ALERT SERVICE BULLETIN

Replacement of turbocharger valve housing for ROTAX® 915 i (Series) and 916 i (Series) Aircraft Engines

ATA System: 78-10-00 Turbocharger

Fig. 1
Parts requirement per engine

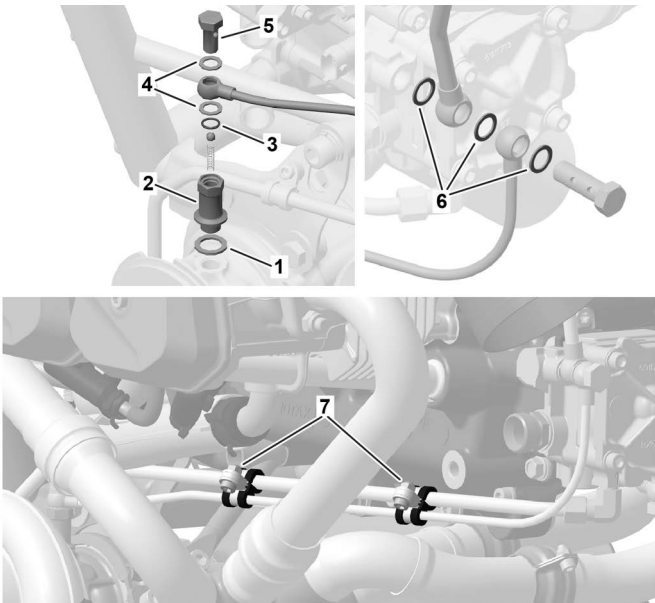
Fig.no.	New part no.	Qty/ engine	Description
1-1	250646	1	SEALING RING A12X18-CU
1-2	956492	1	VALVE HOUSING
1-3	631140	1	O-RING DIN 3771-8X1,5-N, FPM 80
1-4	950141	2	SEALING RING A8X13
1-5	840733	1	BANJO BOLT M8X1X18,5
1-6	230150	3	SEALING RING A10X14
1-7	942021	2	LOCK NUT I-M5-6

Fig. 2
Parts requirement per Turbocharger assy.

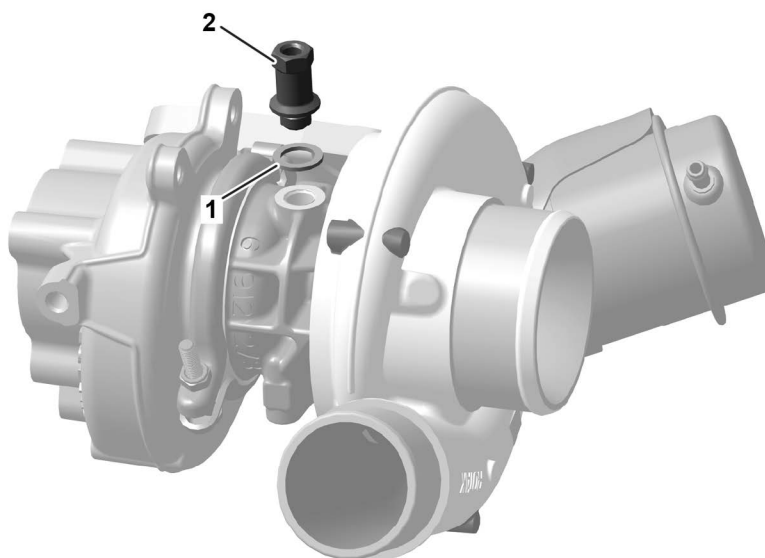
Description	Part no.	Qty/turbocharger
SEALING RING A12X18-CU	250646	1
VALVE HOUSING	956492	1

Fig. 3

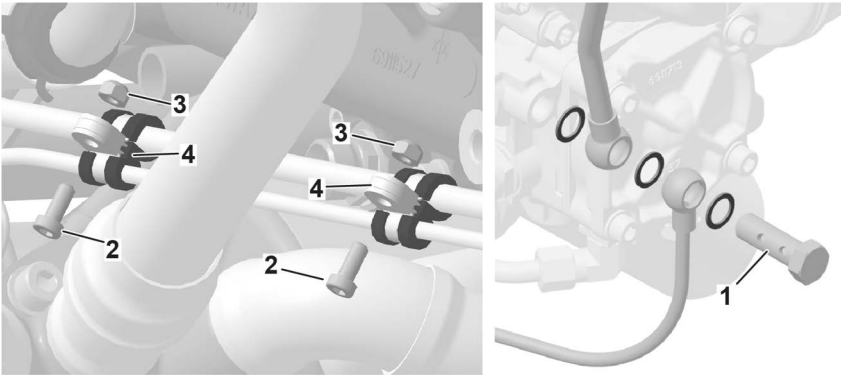
Step	Procedure
1	Remove banjo bolt M10X1X34 (1) from the turbo pressure oil line at the oil pump housing.
2	Remove Allen screws M5X12 (2), lock nuts M5 (3) and cable clamps 5/M5 (4).

Fig. 4

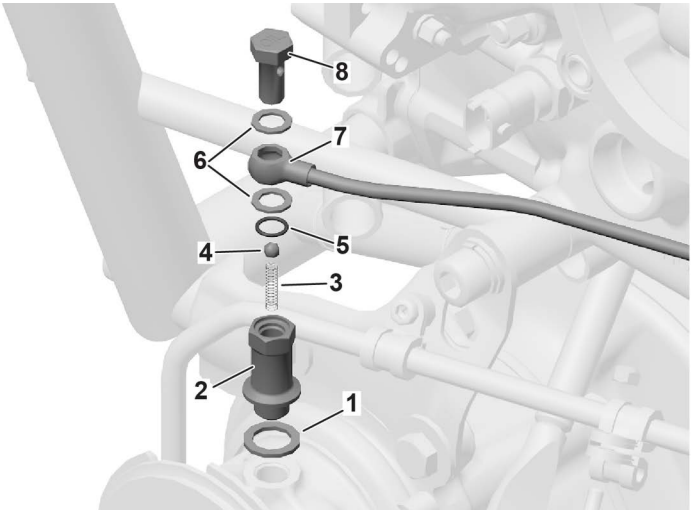
Step	Procedure
3	Remove the turbo pressure oil line (7) with sealing rings (6) by loosening the banjo bolt (8) at the valve housing (2).
4	Remove the valve housing (2) with the compression spring (3) and the ball (4) including the O-ring (5) and sealing ring (1). NOTE: Be sure not to lose the ball and the compression spring.

Fig. 5

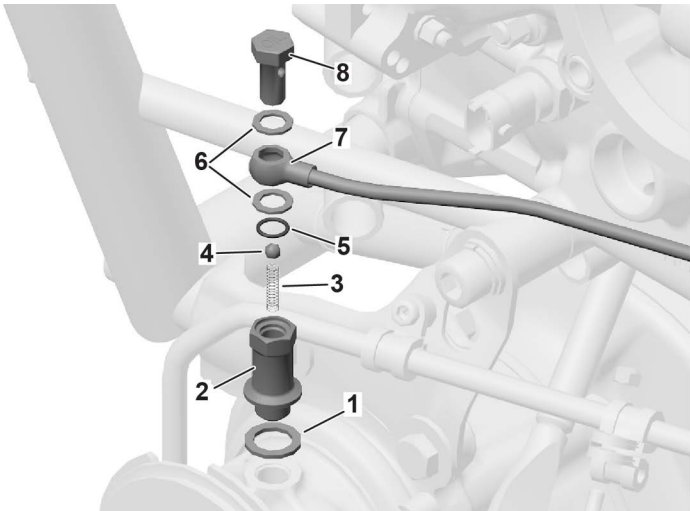
Step	Procedure
1	Install new valve housing part no. 956492 (2) with new sealing ring A12 (1). Tightening torque 25 Nm (18 ft.lb).
2	Place the compression spring (3), ball 5.556 (4) and new O-ring 8X1.5 (5) into the valve housing.
3	Attach turbo pressure oil line (7) to the valve housing using new sealing rings A8 (6) and banjo bolt part no. 840733 (8), hand tighten only.

Fig. 6

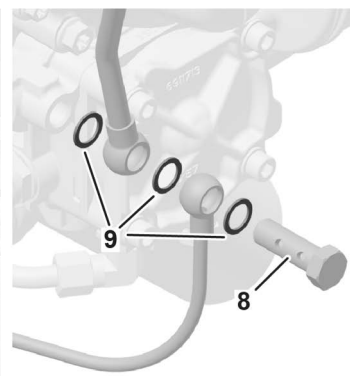
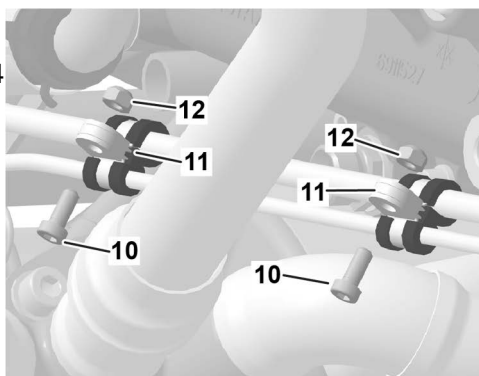
Step	Procedure
4	Attach the turbo pressure oil line at the oil pump housing using banjo bolt M10X1X34 (8) and new sealing rings A10 (9), hand tighten only.
5	Attach cable clamps 5/M5 (11) with Allen screw M5x12 (10) and new lock nut M5 (12). Tightening torque 5 Nm (44 in.lb).
6	Tighten banjo bolt M10 at the oil pump housing (8) to 15 Nm (133 in.lb).
7	Tighten banjo bolt M8 at the valve housing to 17 Nm (150 in.lb).
8	Proceed to section 3.6) Finishing work.

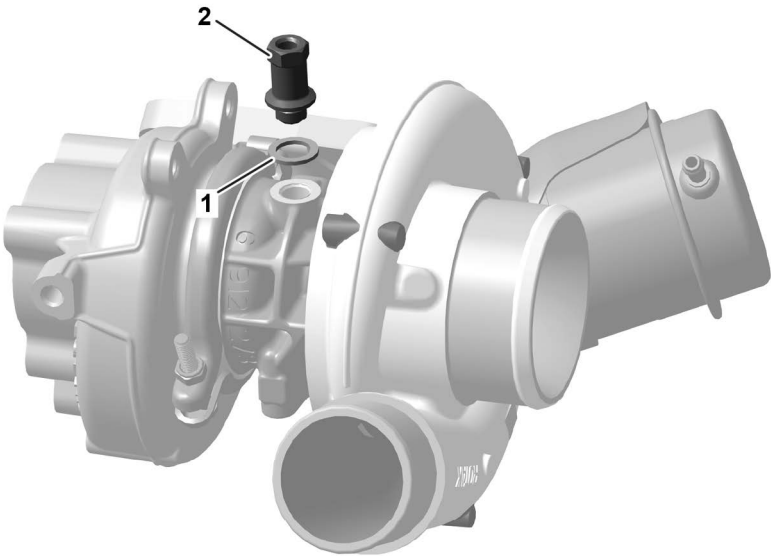
Turbocharger assy. packaged part no. 893102 delivered as a spare part within the serial numbers stated in section 1.1, Criterion B, is fitted with an affected valve housing. The valve housing must be replaced before the turbocharger is installed on an engine.

Step	Procedure
1	Check the turbocharger assy. S/N against the list given in Chapter 4.2) Appendix, to determine if the turbocharger is affected.
2	Remove and discard the affected valve housing together with the sealing ring A12X18-CU. NOTE: Be sure not to lose the ball and the compression spring.
3	Install the new valve housing part no. 956492 with a new sealing ring A12X18-CU part no. 250646. Tightening torque 25 Nm (18 ft.lb).
